**Drain:** SADDLE CREEK DRAIN **Drain #:** 295  
**Improvement/Arm:** SADDLE CREEK-SECTION 6  
**Operator:** SLM/JDM **Date:** 6-21-04  
**Drain Classification:** Urban/Rural **Year Installed:** 1998

RE: Saddle Creek Drain, Section 6 Arm

Re: Saddle Creek Drain: Sec. 6 Arm

SADDLE CREEK SEC. 6

DWG. TYPE	FILE NUMBER	SHEET:
		<b>C701</b>
JOB NUMBER	960324-20000

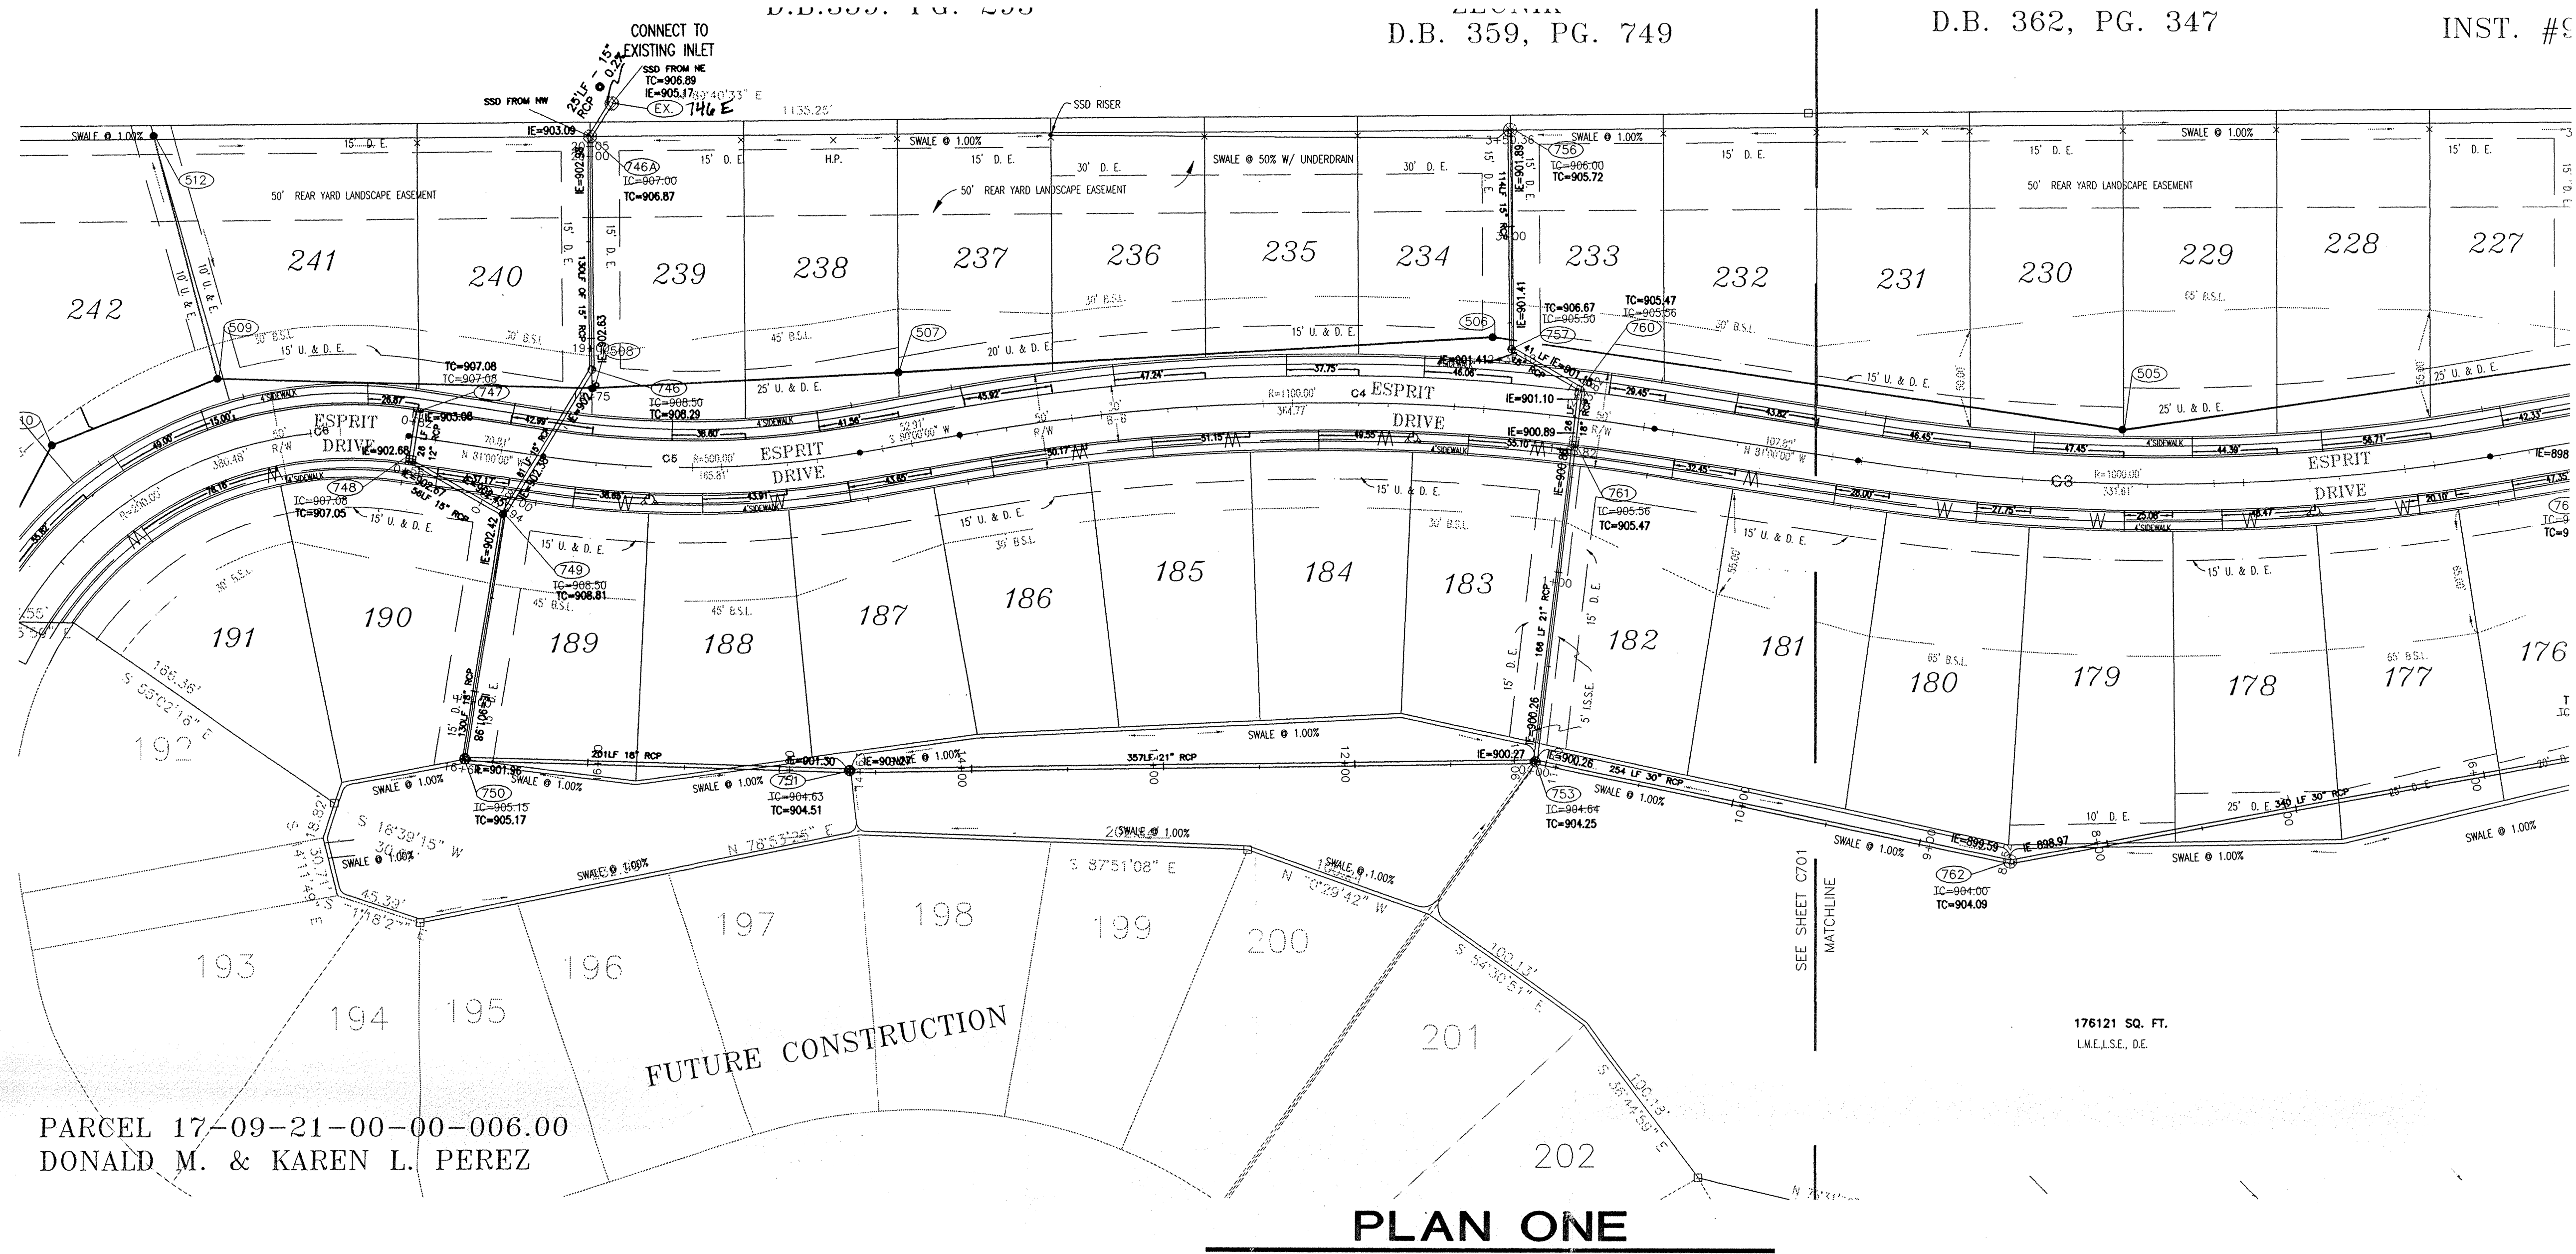
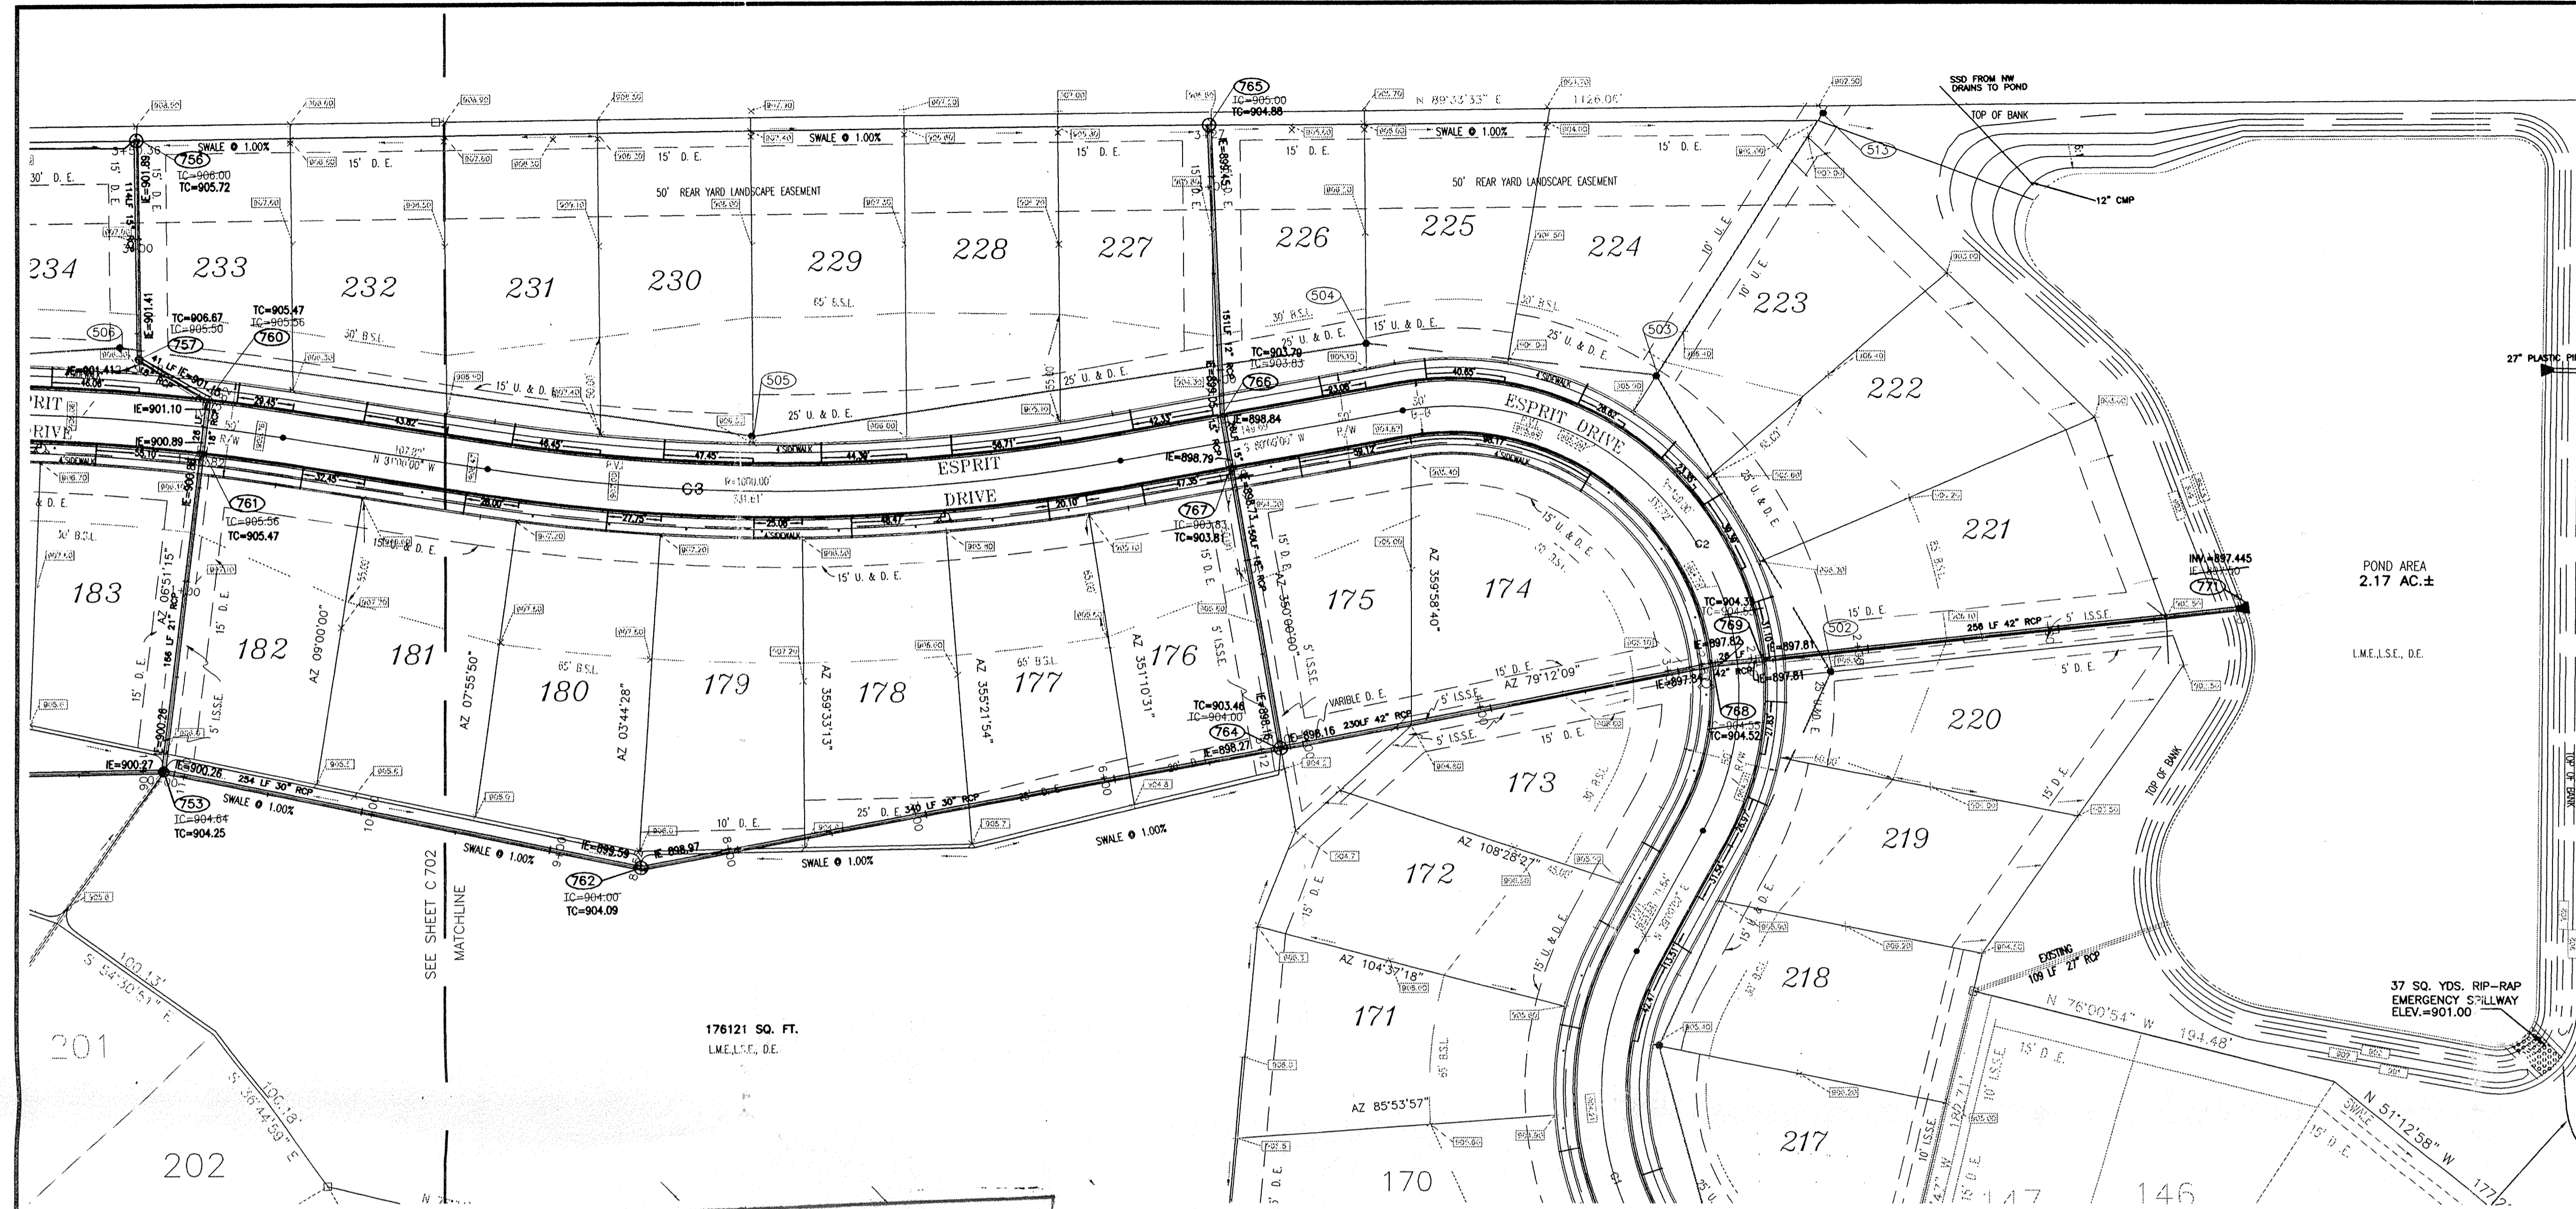
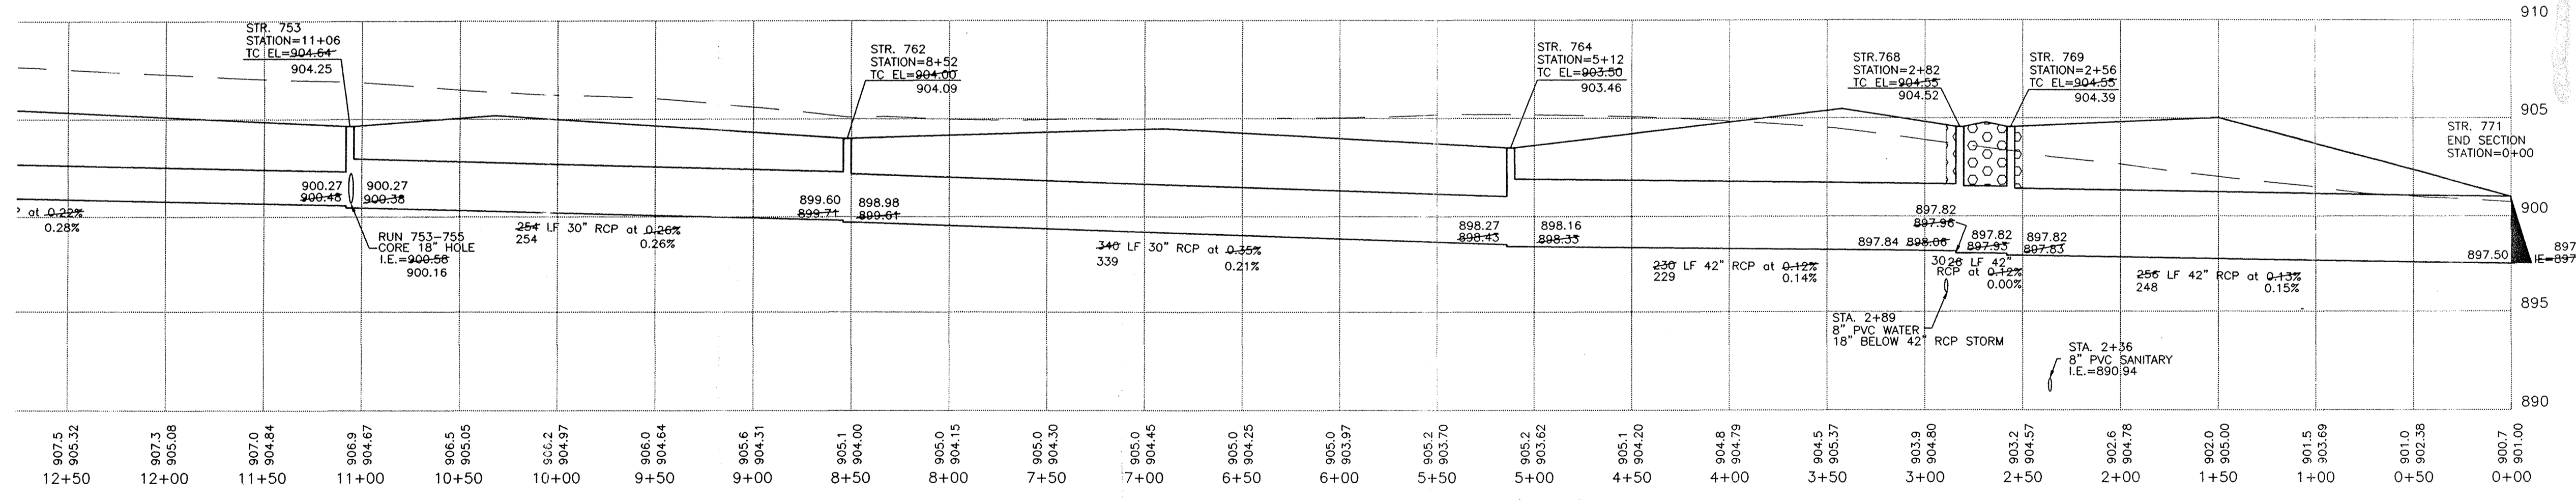
CERTIFIED BY:	REVISIONS	REVISIONS
	6/8/98 REVISED TOP OF CASTINGS	EFB
DATE:	6/23/98 H. C. SURV. OFFICE REVISIONS	EFB
	8/27/98 REVISED STORM RUN 753-756	EFB
	8/20/99 STORM AS-BUILTS	MAV
